Lower Thames Crossing

5.4.1.1 Draft Agreed Statement of Common Ground between (1) National Highways and (2) the Environment Agency (Tracked changes version)

Status of the Statement of Common Ground

Figure 1: Impact of increased defence levels on breach start and end times at Mardyke Sluice breach (based on future level for Option 1.4 in 2127)

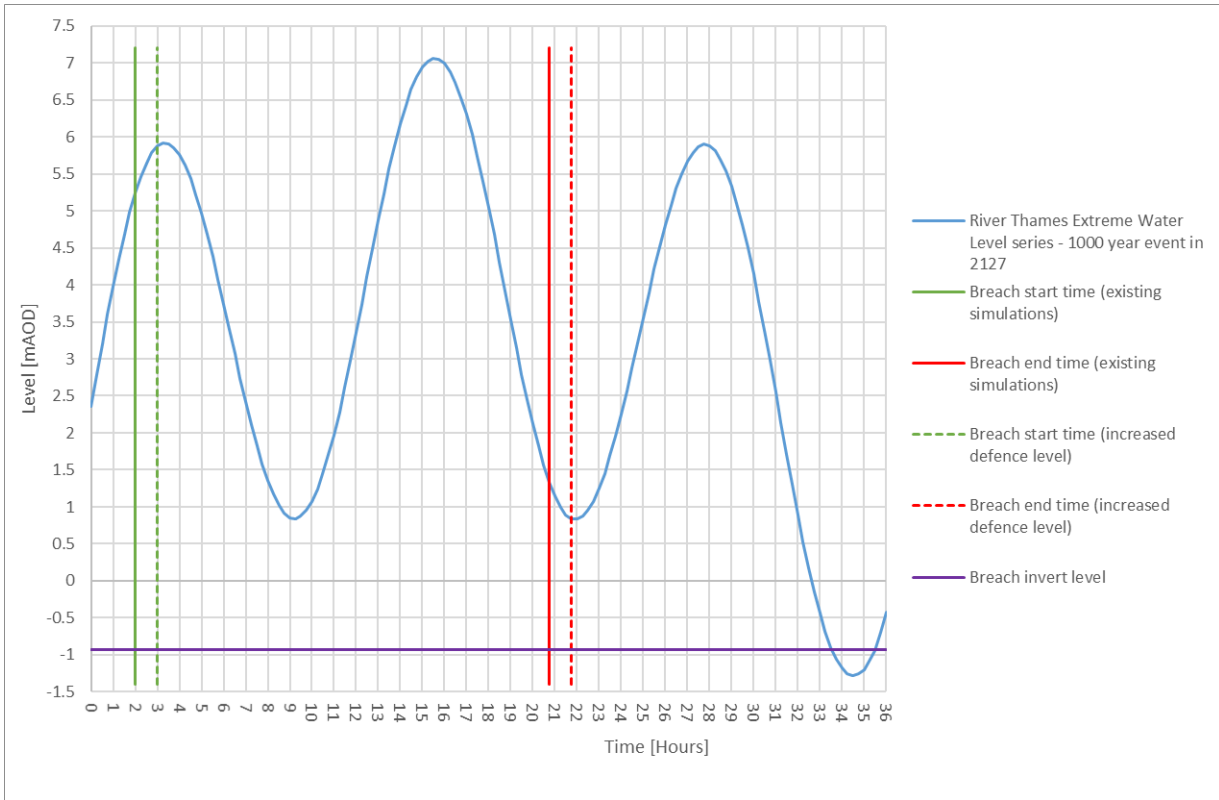
- 2.2.4 Figures 1 to 3 show the influence of increasing flood defence levels on breach start and end times for the LTC FRA breach simulations. The change in breach start and end times is shown for the highest required future defence levels (i.e. the future defence levels that are most different to those assumed in the LTC FRA breach simulations, highlighted in orange in Table 2).

2.2.5 Figures 1 to 3 show that for all LTC FRA breach locations, applying higher flood defence levels results in a delay in the start and end times of simulated breaches. An inspection of Figures 1 to 3 indicates that the reduction in initial breach flows resulting from increased defence levels (due to a delayed start) would exceed the gain in breach flows at the end of the simulated breach event, as River Thames flood levels are higher at the start of simulated breach events than at the end of the events (and for TIL005 there would be no gain in breach flows at the end of the simulated breach event, as River Thames levels would be below the TIL005 breach invert level at the end of the simulated beach). There would therefore be an overall reduction in simulated breach flood volume as a result of increasing flood defence levels.

Figure 2: Impact of increased defence levels on breach start and end times at TIL005 breach (based on future level for Option 3.2 in 2127)

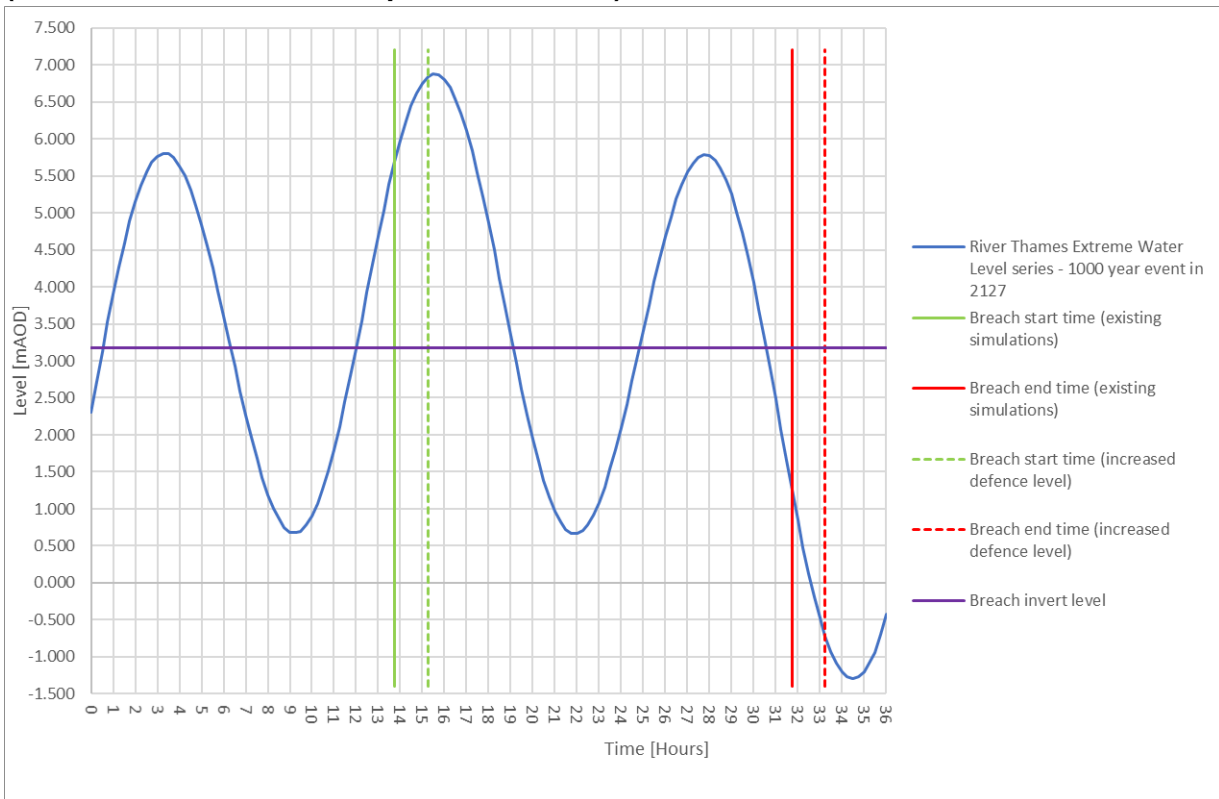
2.2.6 The LTC FRA breach simulation results show the nearest parts of the LTC Project within TIL005 and TIL006 breach event flood extents are approximately 2km and 0.8km respectively from the breach locations, with simulated peak velocities significantly lower than at the breach locations. The influence of an increase in flood defence levels on breach impacts at the LTC Project would therefore be dominated by total breach volume (i.e. breach flood extent and level).
